Release Note

Software Version: 2.12.22.2

Models: X3V/X3SW/X3S (P) Lite/X3S (P) Pro/X3SGPro/X3SGLite/X3UPro

Date: 2025.4.28

3. Add Support for Chinese Input Method on the Phone

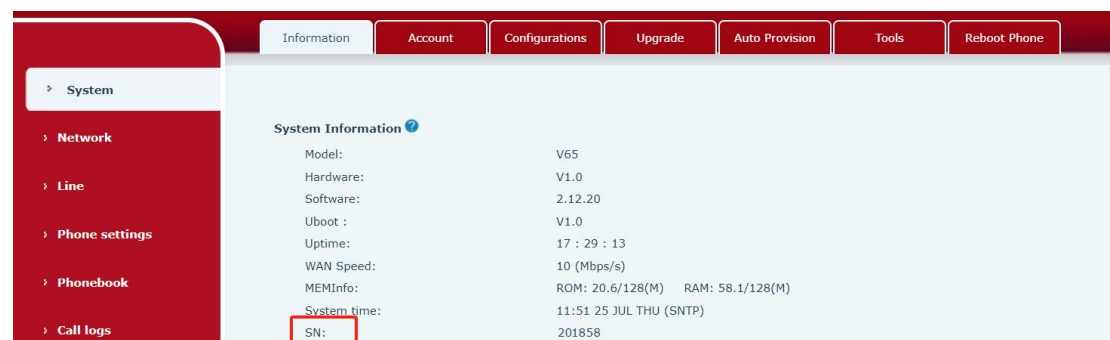
Modify the phone's LCD language to Chinese or Traditional Chinese.

When selecting an editable field or creating a new message, the input method sequence should be: Abc, 2aB, Pinyin, 123, abc, ABC.
